Municipal Planning & Design Review Commission
Regular Meeting Agenda
Thursday, August 19, 2021, 5:30 PM
City Hall, Lakeland, Tennessee 38002

Subject: Action on approval of a Site Plan at 3469 Lake District Drive N – Lake District Outparcel 6.

We are pleased to submit the following responses to the staff comments regarding Lot 6 of the Lake District. The original staff comment is shown, followed by our response in green text.

29 DUMPSTER PLAN

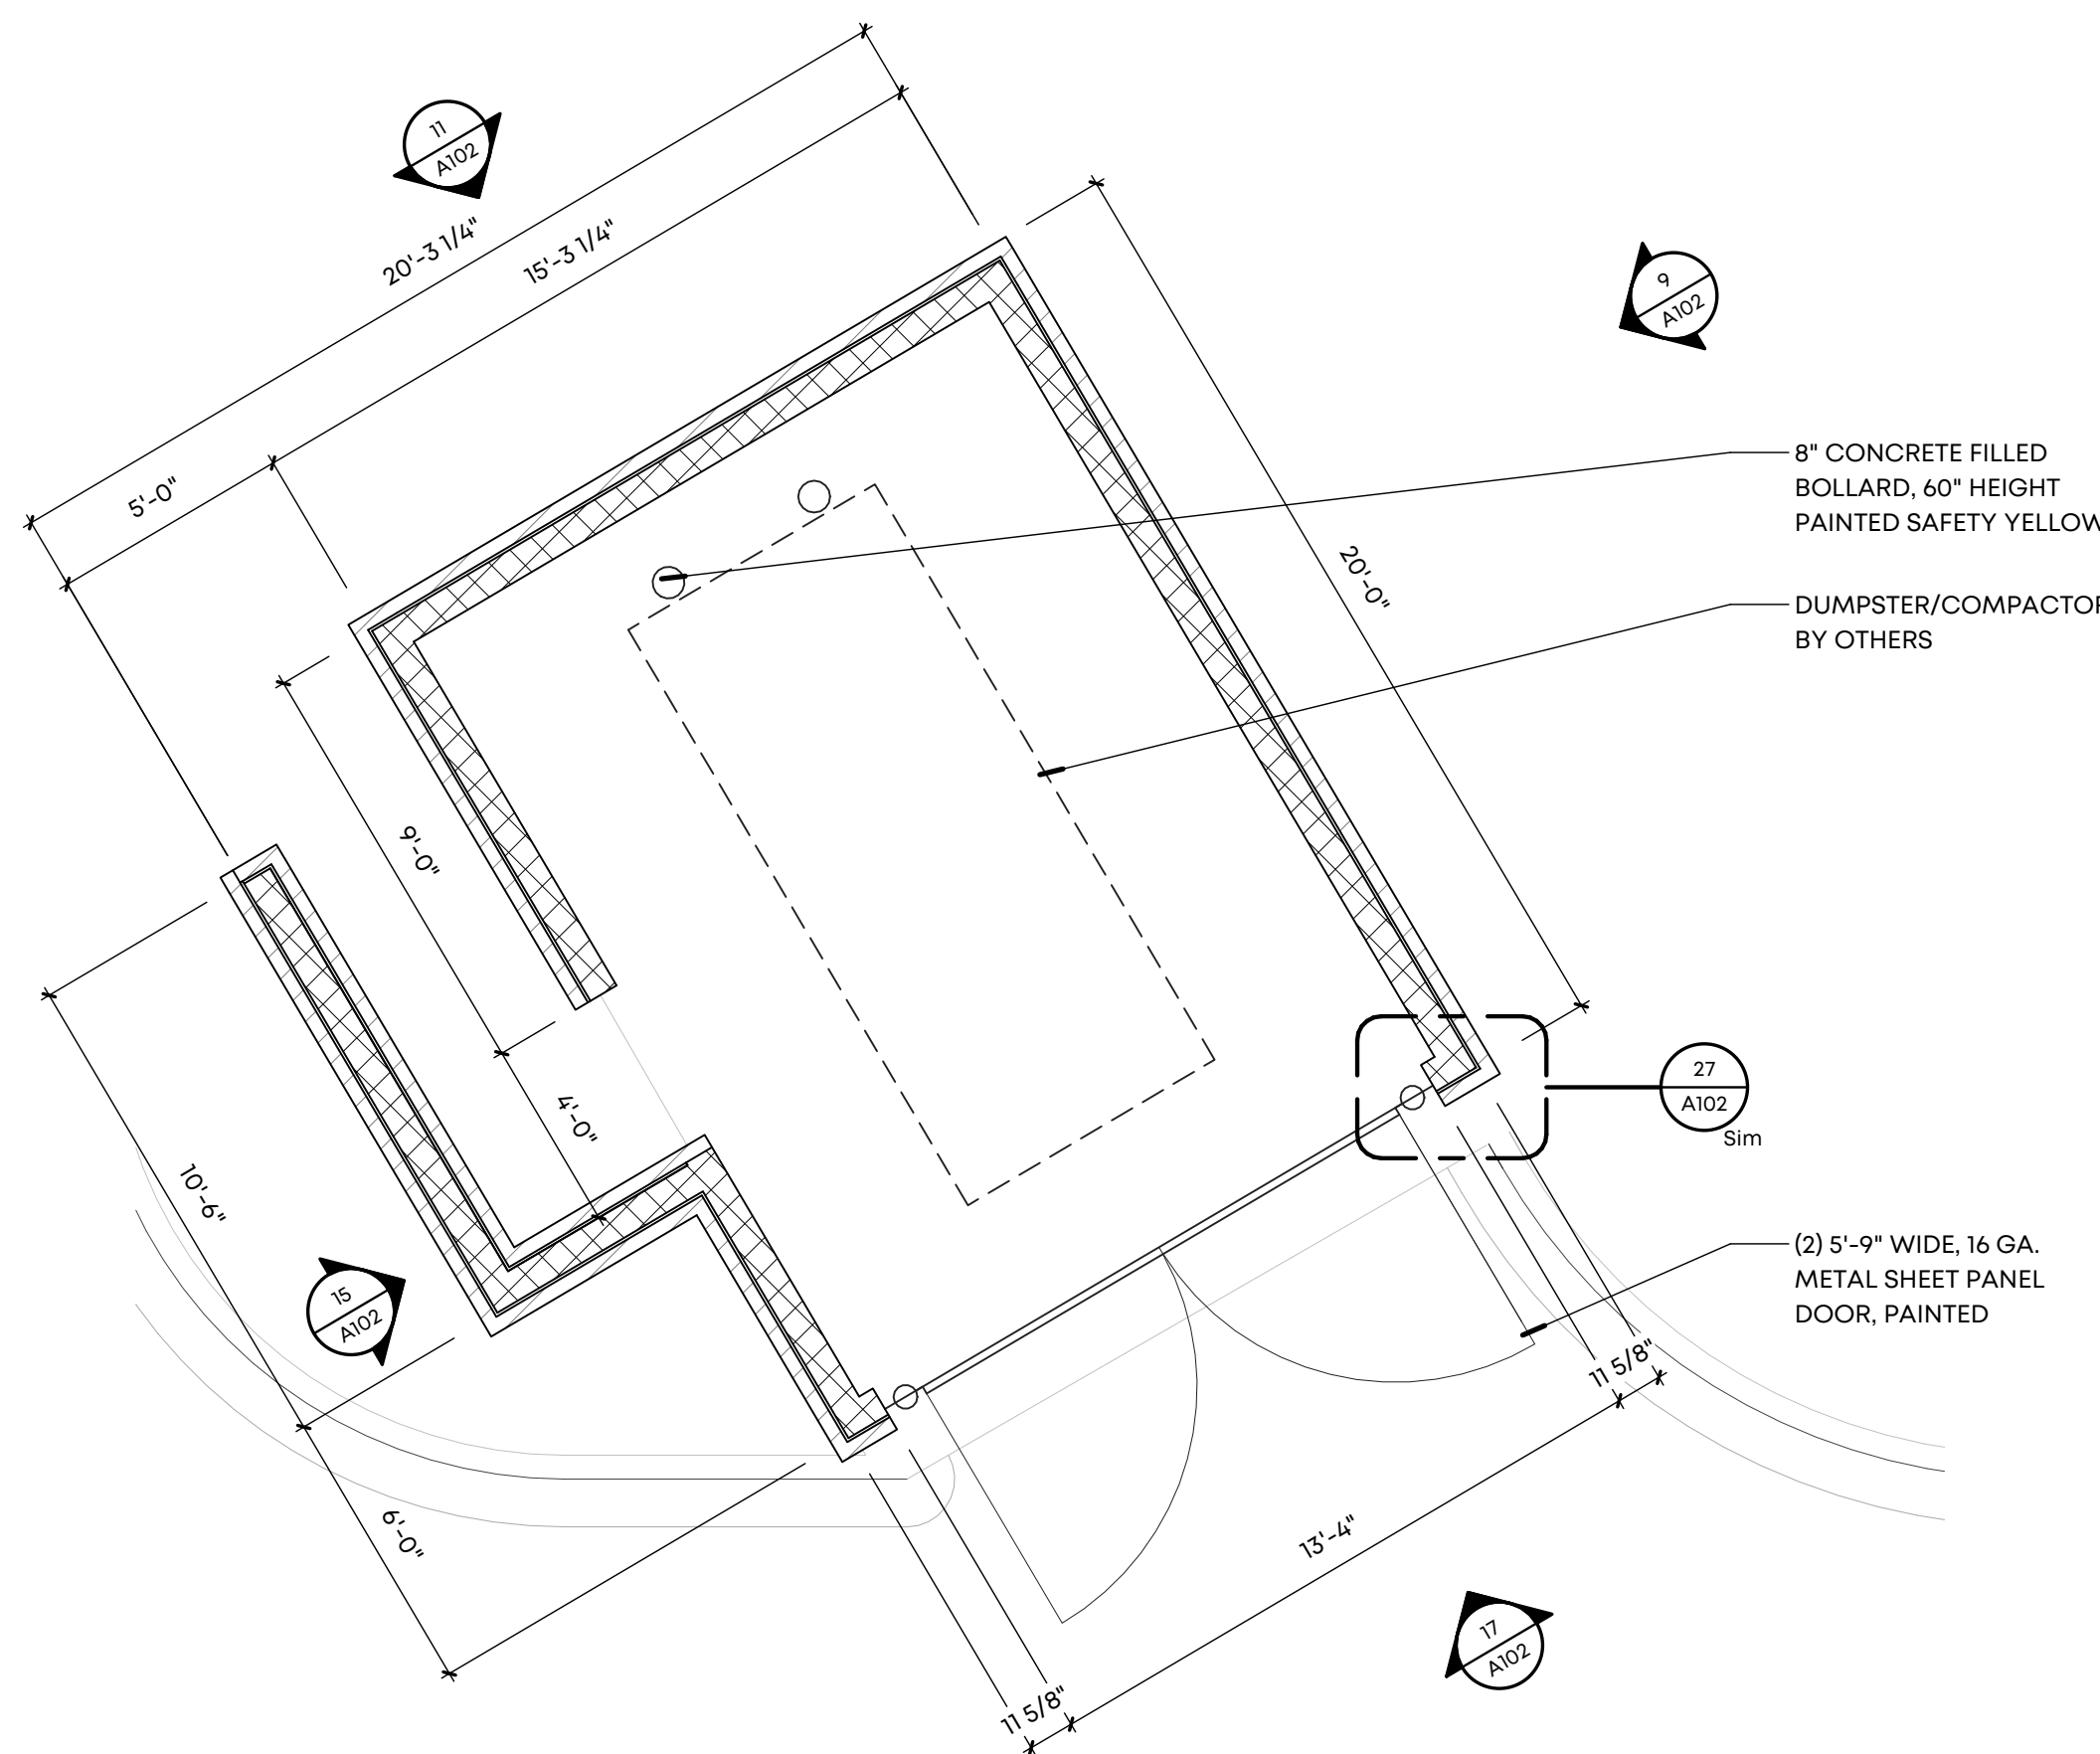
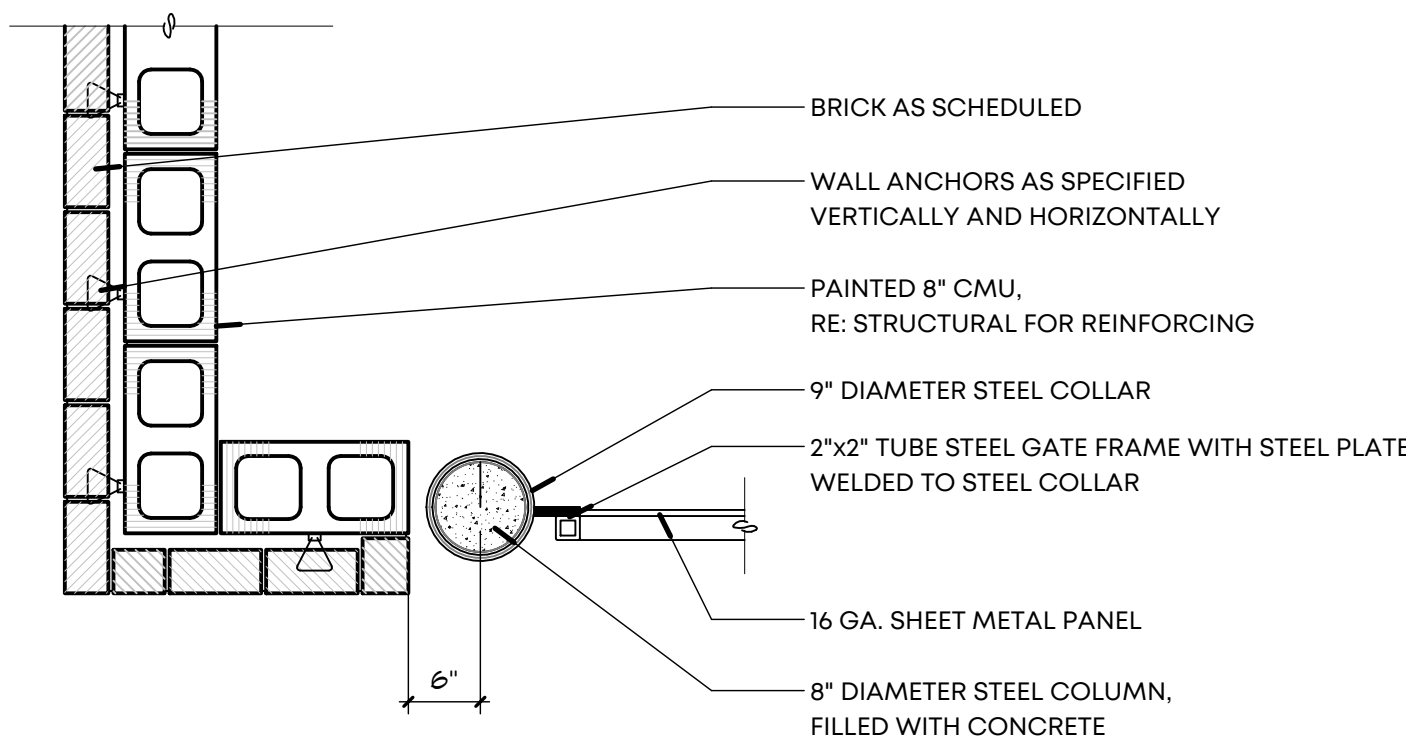
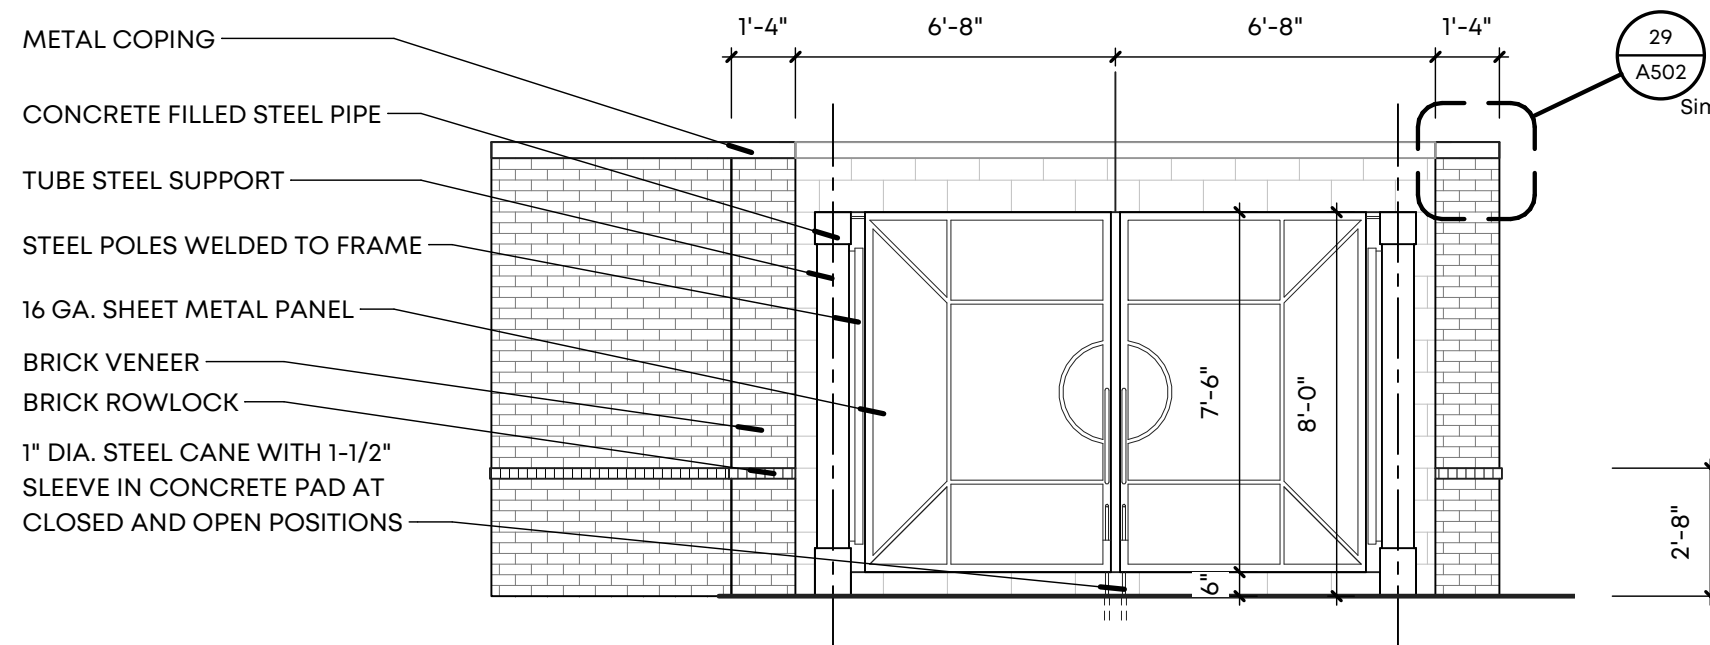
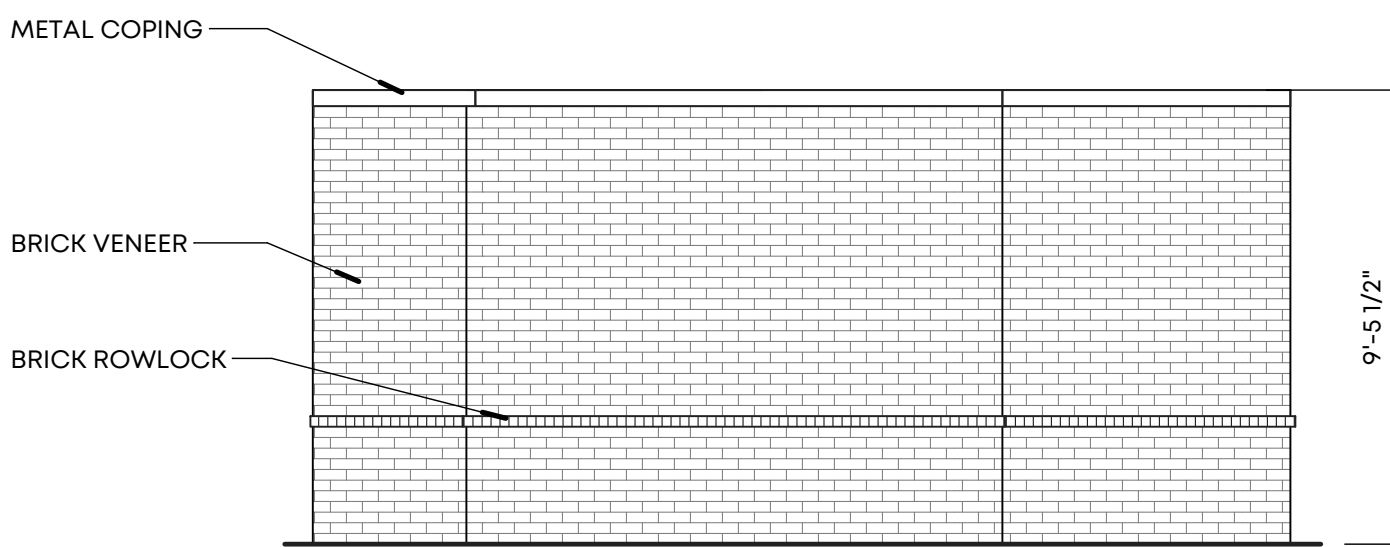
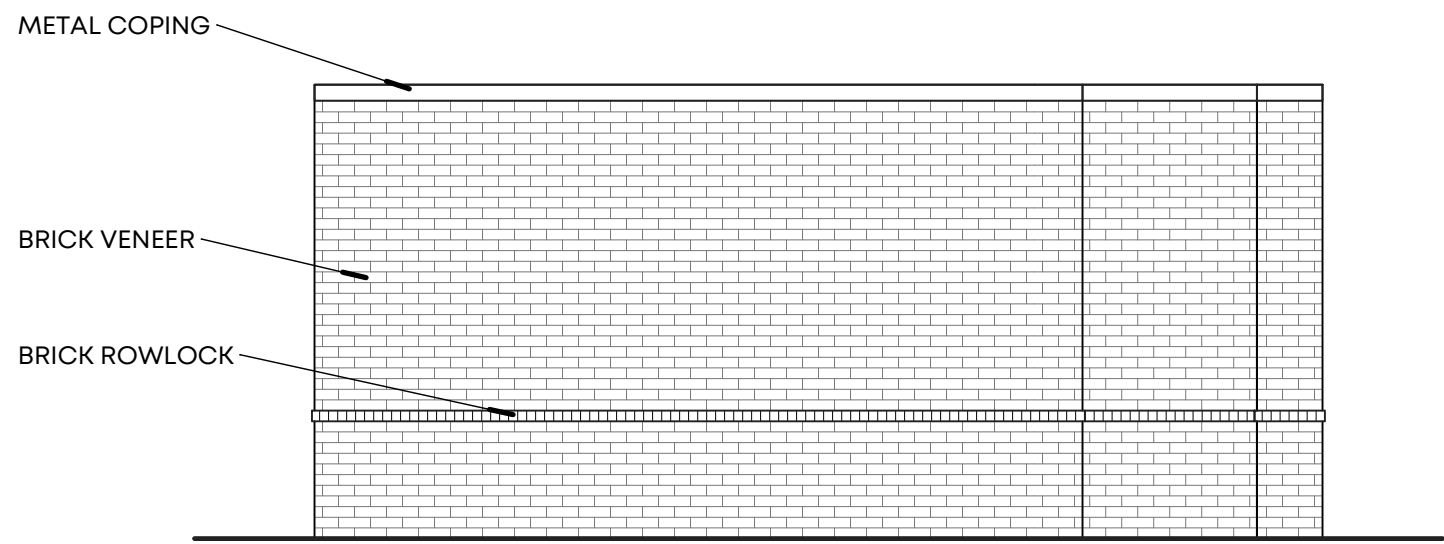
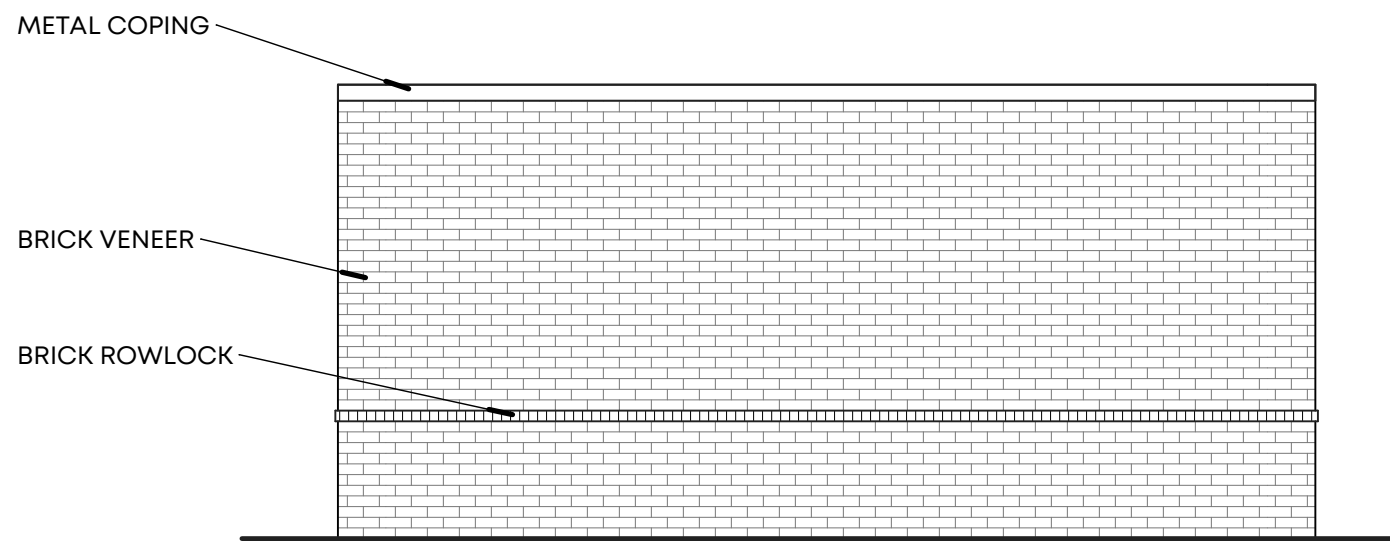
2. Provide elevations of dumpster enclosure including materials to be used.

Ref. enclosed dumpster enclosure drawing, which will be similar to the existing Starbucks enclosure.
